Document Review Comment Sheet

PEB Ref. No : TB2-PEB-SDC-M1B-TVI-02734

PROJECT TITLE THAI BINH2 THERMAL POWER PLANT 2 x 600MW

DRAWING TITLE HP FEEDWATER HEATER #6
11LAD10AC006/21LAD10AC006
DETAIL OF NOZZLE (3/4)

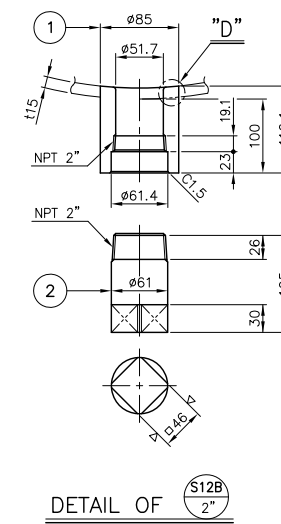
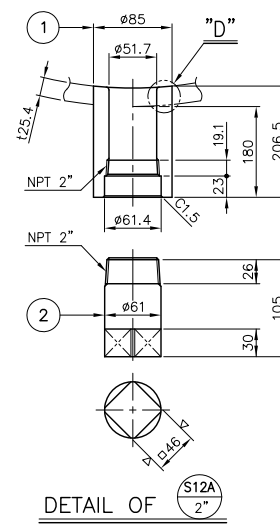
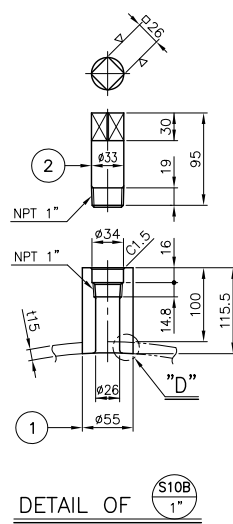
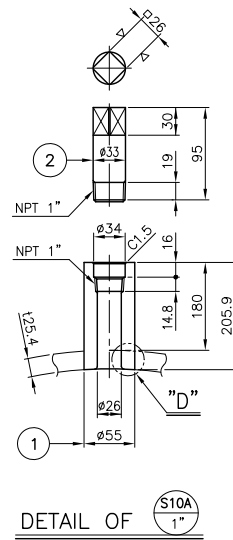
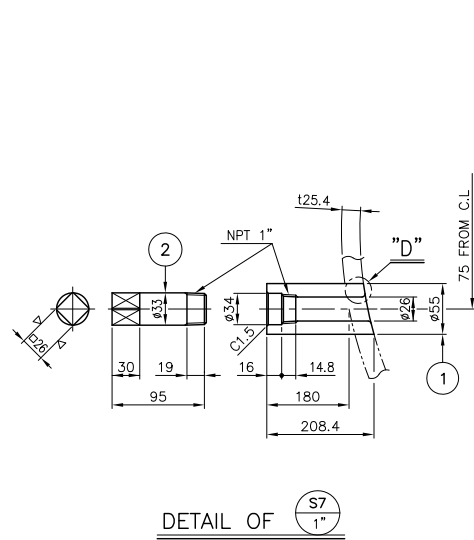
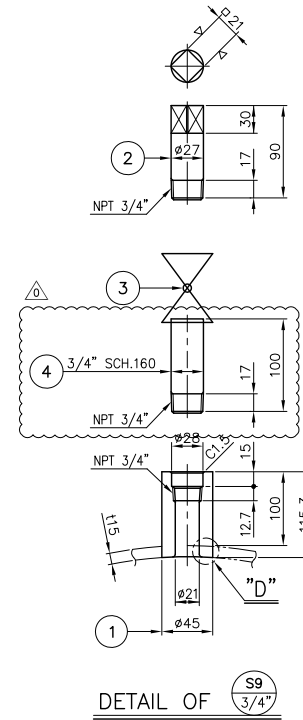
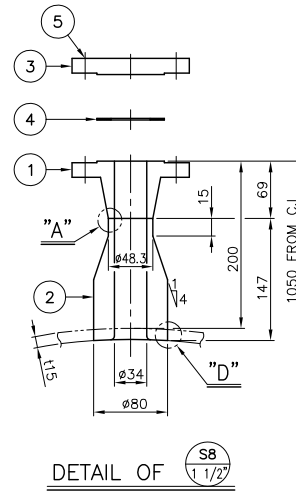
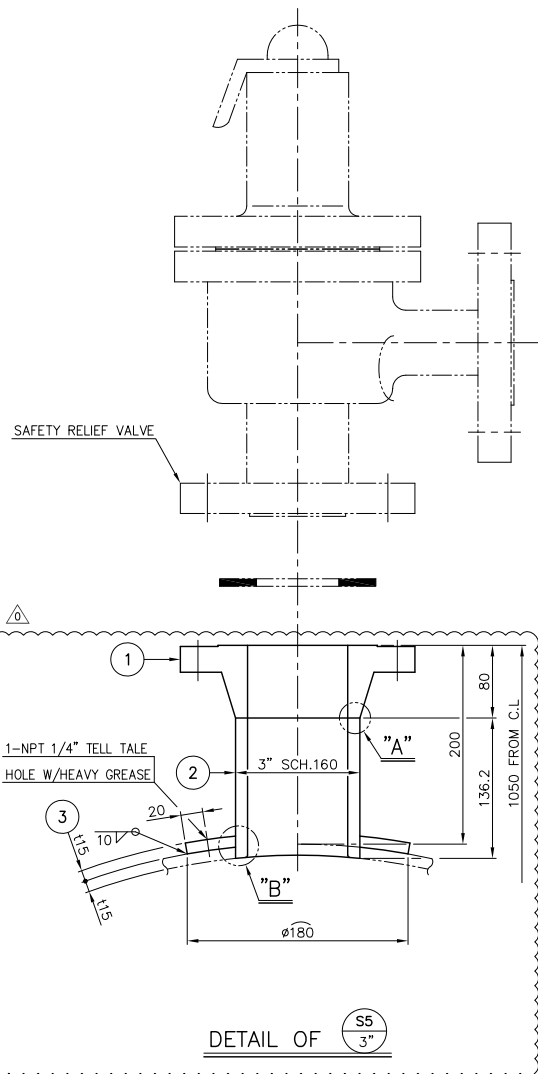
No.	Owner/PMC's comment		Contractor's Response			
	General comment					
1	The Title of drawings should be as bellows: - HP FEEDWATER HEATER #6_GENERAL ASSEMBLY (sheet 1/19) - HP FEEDWATER HEATER #6_SHELL SUB ASSEMBLY (sheet 2/19) - HP FEEDWATER HEATER #6_SKIRT & TUBESHEET ASSEMBLY (sheet 3/19) - HP FEEDWATER HEATER #6_DESUPERHEATING SUB ASSEMBLY (sheet 4/19) - HP FEEDWATER HEATER #6_DRAIN COOLING SUB ASSEMBLY (sheet 5/19) - HP FEEDWATER HEATER #6_DETAIL OF TUBE BUNDLE BUNDLE (sheet 6/19) - HP FEEDWATER HEATER #6_DETAIL OF TUBE BUNDLE (sheet 7/19) - HP FEEDWATER HEATER #6_DETAIL OF TUBE BUNDLE (sheet 8/19) - HP FEEDWATER HEATER #6_DETAIL OF TUBE BUNDLE (sheet 9/19) - HP FEEDWATER HEATER #6_HEMI. HEAD & PASS PARTITION DETAIL (sheet 10/19) - HP FEEDWATER HEATER #6_DETAIL OF SADDLE (sheet 11/19) - HP FEEDWATER HEATER #6_FOUNDATION DRAWING (sheet 12/19) - HP FEEDWATER HEATER #6_DETAIL OF MANHOLE (sheet 13/19) - HP FEEDWATER HEATER #6_DETAIL OF NOZZLE (sheet 14/19) - HP FEEDWATER HEATER #6_DETAIL OF NOZZLE (sheet 15/19) - HP FEEDWATER HEATER #6_DETAIL OF NOZZLE (sheet 16/19) - HP FEEDWATER HEATER #6_DETAIL OF NOZZLE (sheet 17/19) - HP FEEDWATER HEATER #6_DETAIL OF INSULATION SUPPORT (sheet 18/19) - HP FEEDWATER HEATER #6_DETAIL OF NAME PLATE (sheet 19/19)		We will add sheet number.
